**REPORT OF THE
COMPTROLLER GENERAL
OF THE UNITED STATES**

**Actions Needed To Increase
The Safety Of Dams Built By
The Bureau Of Reclamation And
The Corps Of Engineers**

CED-77-85

JUNE 3, 1977

EMBANKMENT EXPLANATION

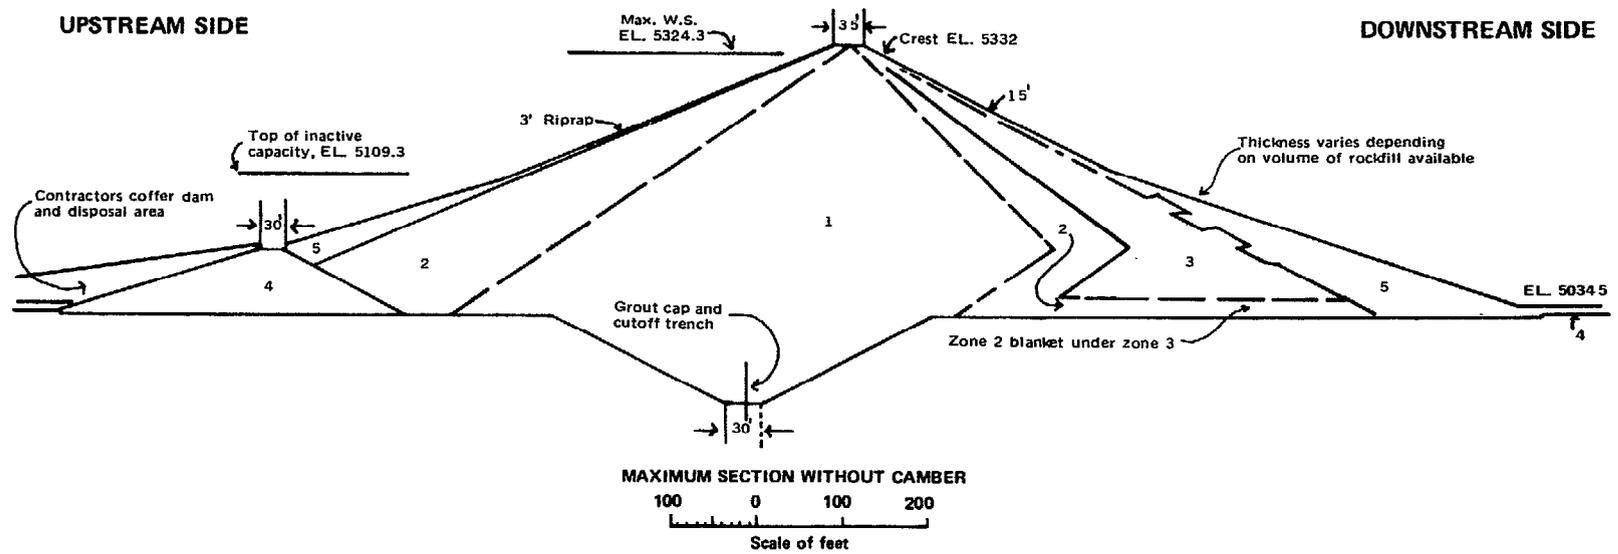
While the Teton Dam design made provisions for filtration and drainage, the Independent Panel raised questions regarding the lack of filters in key trench areas and the effectiveness of the downstream drainage system. The Independent Panel concluded that one critical design decision that allowed the Teton failure to occur was that inadequate provisions were made for the collection and safe discharge of leakage or seepage.

The Bureau relied on the Zone 2 material to collect seepage that would penetrate the impervious core and carry the seepage safely out of the dam. (See p. 28.) However, the Independent Panel questioned whether this zone provided effective drainage because test results indicated that the

PROFILE OF KEY AND CUTOFF TRENCHES

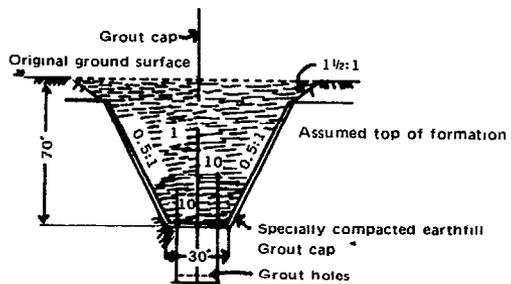
The Independent Panel also questioned the lack of a filter on the downstream side of the key trench. As previously described, the fine, highly erodible Zone 1 material was placed directly against the highly cracked rock. Thus, there were many places where seepage going through the key trench could escape and carry with it the fine grained Zone 1 material.

The Independent Panel said that the shape of the key trench, with its rigid rock walls and steep slopes, was favorable to the development of cracks through arching and hydraulic fracturing. Arching (see p. 37) prevents the full weight of the overlying embankment from bearing on the underlying material. If the arching effect reduces the pressure on the underlying materials sufficiently, water pressure can crack the soil by the process known as hydraulic fracturing. Based on observations, tests, and analyses, the Panel concluded that hydraulic fracturing of the soil in the key trench was a highly probable mechanism for the initial breaching of the key trench.

GROUT CURTAIN

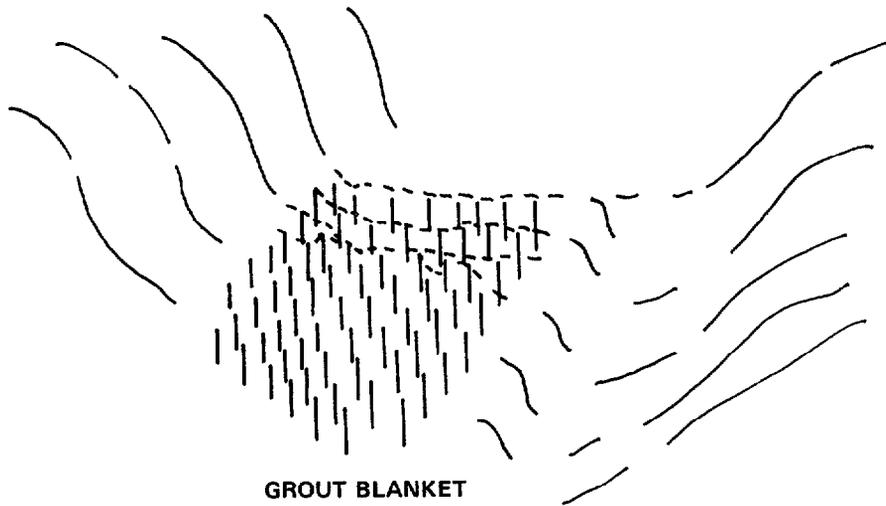
and other materials into the foundation at a cost of about \$4 million. Yet, the grout curtain may not have been effective in controlling seepage as intended. The Independent Panel concluded from its postfailure tests that water could pass through the grout curtain at several locations. Thus, it concluded that the grout curtain may not have been fully effective in controlling seepage in the critical key trench area. The Independent Panel questioned the adequacy of the design of the grout curtain as well as the heavy reliance placed on it to control seepage. In addition, there is a question whether additional measures should have been taken to test the adequacy of the grout curtain after it had been constructed.

- The Teton damsite was considered one of the most pervious sites ever built on by the Bureau.
- The Teton design placed a great reliance on the effectiveness of the grout curtain.
- Multiple grout curtains were not built at Teton and the relative ineffectiveness of single-row grout curtains had been questioned for many years.
- Instrumentation to test the effectiveness of the Teton grout curtain was not planned or installed.

EROSION DIAGRAMS

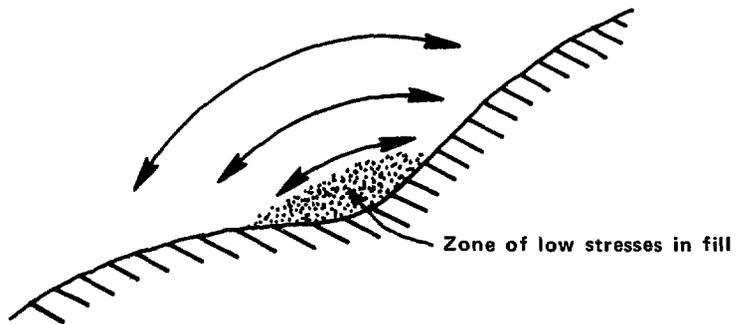
The Panel said that in the bottom of the key trench in the vicinity of the failure, there was a concentration of steps and overhanging rocks which made proper compaction of soil in the trench difficult and was conducive to arching as

RELATIONSHIP OF THE WATER RISE IN THE TETON DAM RESERVOIR TO THE WATER RISE IN THE SURROUNDING GROUND WATER OBSERVATION WELLS

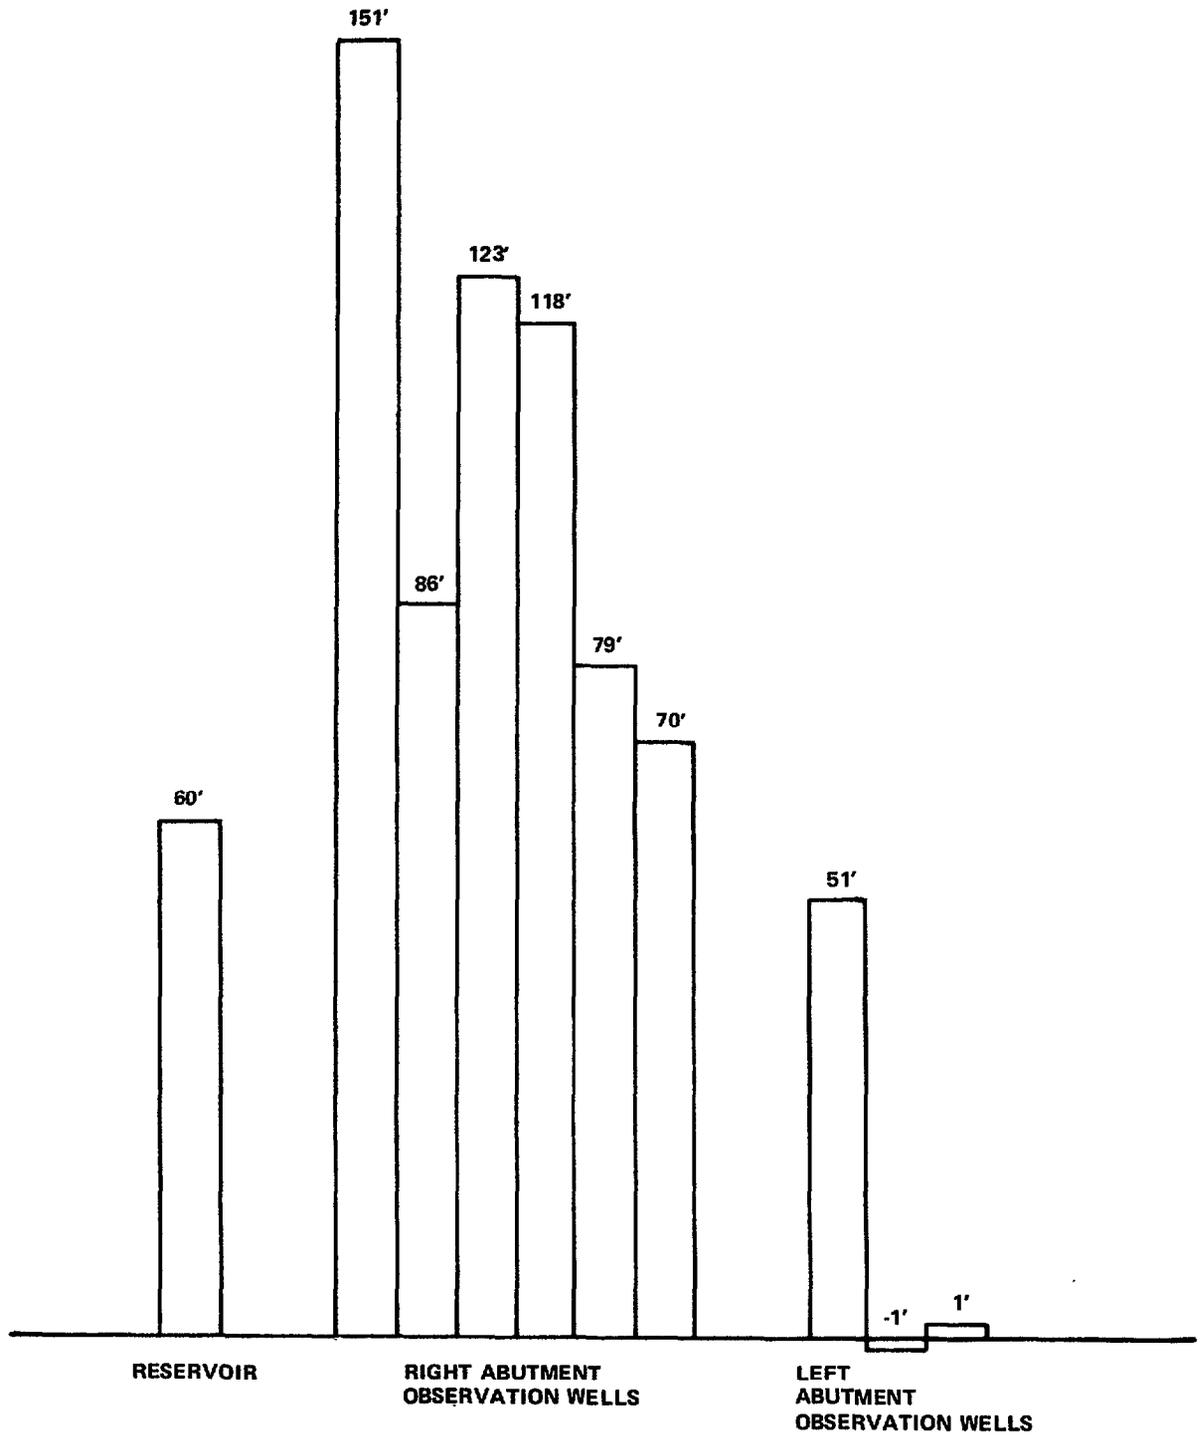
For about a month before the Teton Dam failure, water levels had been rising rapidly in observation wells which

The Project Construction Engineer at the Teton site told us that he expected rapid rises in the wells and that he did not believe that such rises were alarming. Although the weekly frequency of well readings was changed to twice weekly, he said that the once-a-month schedule for transmitting the data to the E&R Center at Denver was not changed.

The ground water specialist at the E&R Center who helped set up the observation well system said that the well readings indicated to him that seepage at the site was greater than he expected. Further, he said the fact that water levels in the wells were in some cases rising faster than the reservoir was an unusual situation, which in retrospect, should have raised a "red flag" to more carefully monitor seepage near the dam.
